Reference: West Vermont Street Drinking Water Site
Speedway, Indiana; Site ID#B5UJ

During the June 16, 2011 meeting regarding the Site, USEPA Region 5 invited all participants to submit comments regarding the March 27, 2011 Weston Solutions *Technical Memorandum Analytical and Hydrogeological Evaluation* (TM) and other data associated with the Site. In this letter, we provide comments regarding the TM, with additional discussion of the information we presented at the June 16, 2011 meeting demonstrating that ATI's facility, located at 4700 West 10th Street, Indianapolis, Indiana 46222 (ATI Facility), has no nexus to the Site. As discussed below, the data conclusively demonstrate that the ATI Facility is not a source and that ATI is not a potentially responsible party (PRP).

B. Comments to the Technical Memorandum Analytical and Hydrogeological Evaluation, prepared on behalf of the USEPA, dated March 27, 2011, by Weston Solutions

Attachment 1: Arcadis Drawings 1 and 6
Attachment 2: Payne Figures 1 and 2
Figure 1 Overlay of Figures 15B & 15C
Figure 2 VC Isocontours Residential Area-Intermediate Water Bearing Zone

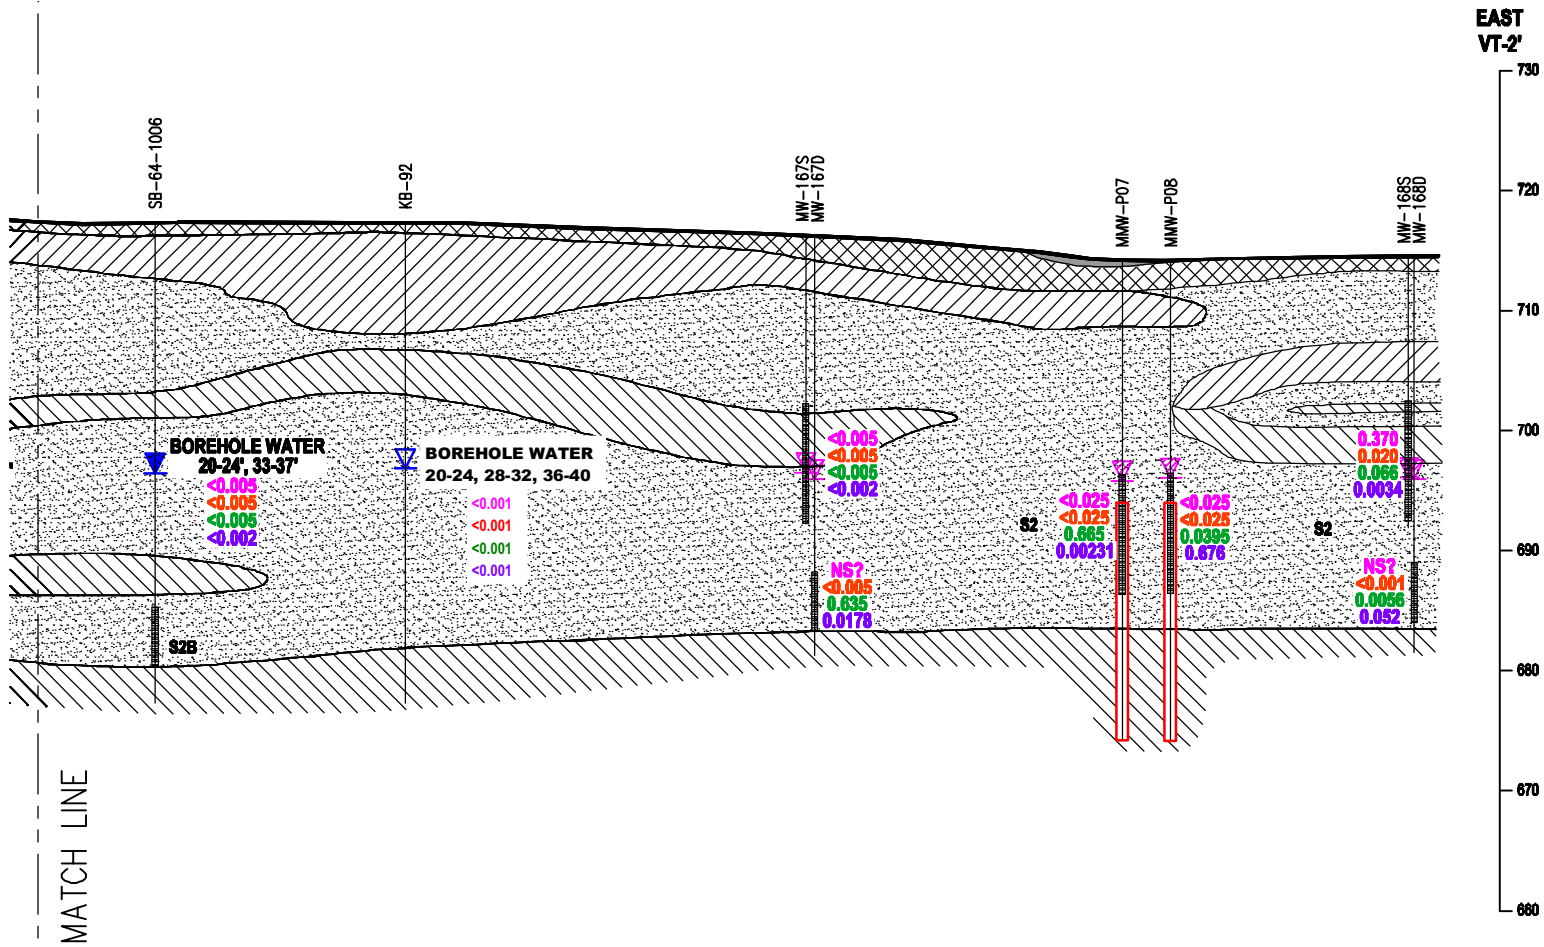
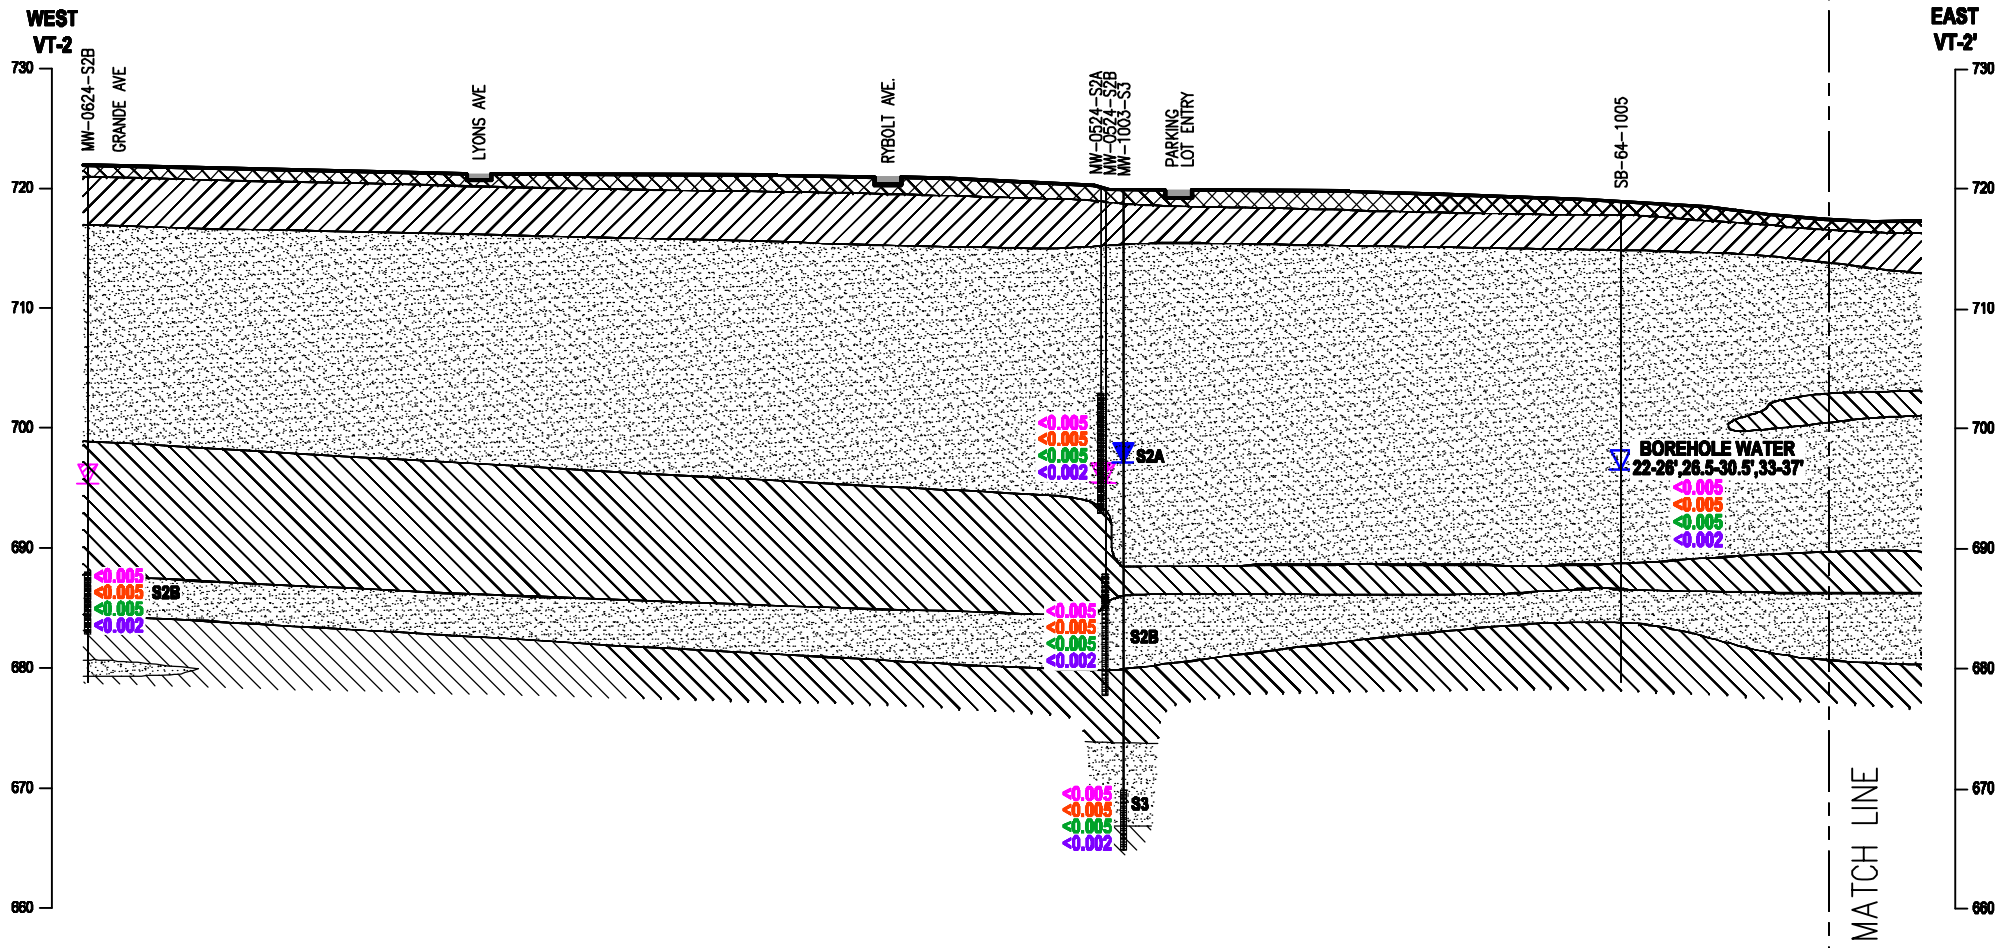
In June 2011, GM sampled adjacent to (and up-gradient from) the Site, including four locations along Michigan Street, which forms the northern up-gradient border of the Site. The groundwater preliminary laboratory analytical data from GM's sampling reveal that no vinyl chloride contamination was identified in the water-bearing zones at any depth, meaning that no plume exists connecting the ATI Facility with the Site. *See* Attachment 1 (Arcadis draft Drawings 1 and 6; Drawing 6 is the cross-section along Michigan Street from Grande Avenue to the east side of the Michigan Plaza Site showing recent data).

As shown on the Arcadis investigation summary (Drawing 1) and cross-section along Michigan Street (Drawing 6), the only vinyl chloride detections are present to the east of the ATI Facility at the Michigan Meadows Apartments and Michigan Plaza Site (MPS), where deeper groundwater has not been investigated by the responsible parties. Furthermore, as discussed below, a commingled vinyl chloride plume is migrating to the Site from sources at the MPS and the Genuine Parts Site (GPS). Simply put, the evidence shows that the ATI Facility is not a source of vinyl chloride groundwater contamination at the Site.

The TM indicates no monitoring wells are located in the residential area south of the ATI Facility. That is not correct. Seven GM installed wells are present (as shown in the GM RFI Figure 3.4.1), four of which are screened in the intermediate water bearing zone (S2). As noted above, the wells were recently (June 2011) sampled and preliminary laboratory analysis did not identify any vinyl chloride (See Attachment 1, Drawing 1).

TITLE		VC ISOCONTOURS INTERMEDIATE WATER BEARING ZONE WEST VERMONT STREET CONTAMINATION SPEEDWAY, MARION COUNTY, INDIANA	
CLIENT		ALLISON TRANSMISSION INC.	
DATE	Friday, July 01, 2011	FIGURE	2
PROJECT NUMBER	533.42.08		
DRAWN BY	JAG

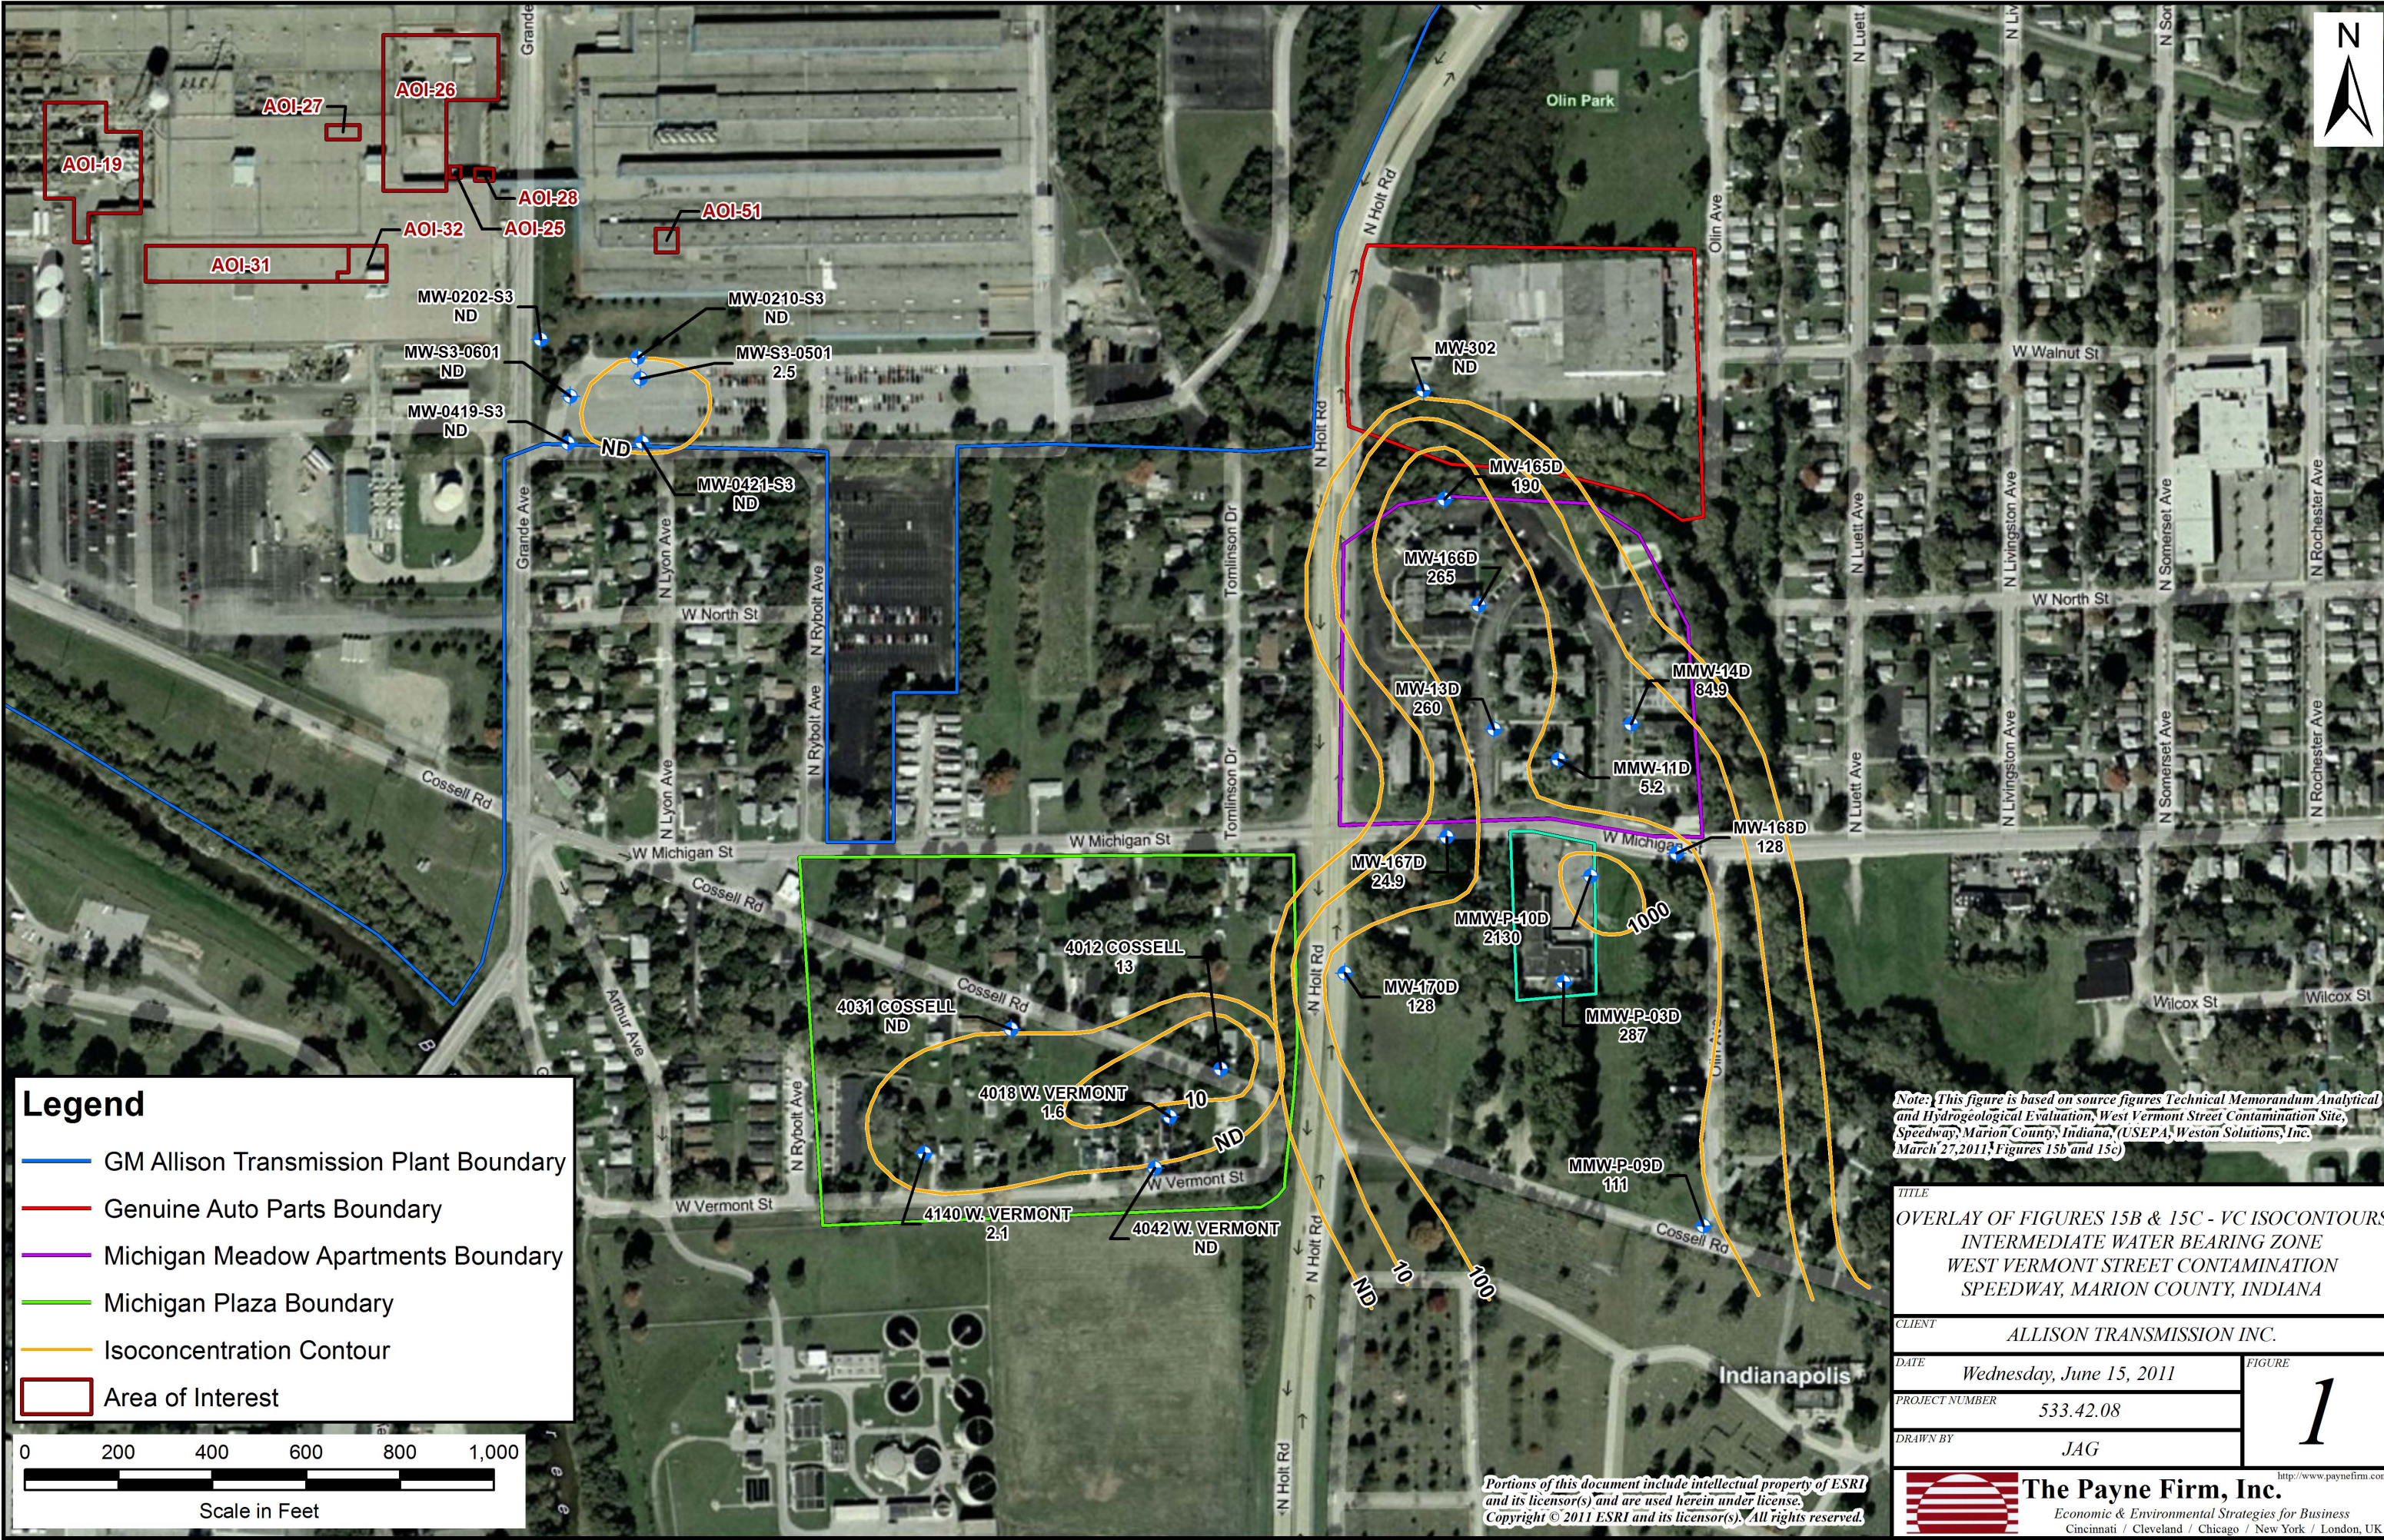
The TM uses data from the three facilities and the Site on common figures to present isocontours for tetrachloroethene (PCE), trichloroethene (TCE) and cis-1,2-dichloroethene (DCE). Vinyl chloride contamination in groundwater is depicted separately for the three facilities and the Site in TM figures 15B and 15C, Vinyl Chloride Isocontours- Intermediate Water Bearing Zone, and Vinyl Chloride Isocontours Residential Area- Intermediate Water Bearing Zone, respectively. The two separate figures suggest two separate groundwater contamination plumes. This is inaccurate and misleading. As discussed during the June meeting, an accurate depiction reveals a single plume that originates from the MPS and/or GPS, and not from the ATI Facility.

As depicted on the Payne Firm-prepared figure that ATI presented at the June 16 meeting, when the TM figures are geospatially co-located in a single figure, the isocontours intersect, indicating the plumes are, in fact, a single areal plume emanating from the Genuine Parts and/or Michigan Plaza sites. See Attachment 2 (Figure 1 Overlay of Figures 15B & 15C and Figure 2 VC Isocontours Residential Area-Intermediate Water Bearing Zone). It is unclear how the TM could have missed this elementary point, but it clarifies what the evidence reveals – namely, that the plume originates from the MPS and/or GPS. Moreover, a distinct westward migration of the plume into the residential well field is evident. Again, the single plume with a westward migration toward the Site demonstrates that the impacts to the Site do not originate at all from the ATI Facility.

Groundwater contamination, including chlorinated solvents and vinyl chloride, has been previously identified and associated with the MPS and the GPS and is present to the adjacent east of the Site. Vinyl chloride plume mapping in the IWBZ clearly identifies (1) a distinct contaminant plume associated with the MPS and/or the GPS, which, due to local influences on groundwater flow direction, has affected the Site, and (2) that the ATI Facility is not associated with the identified plume.
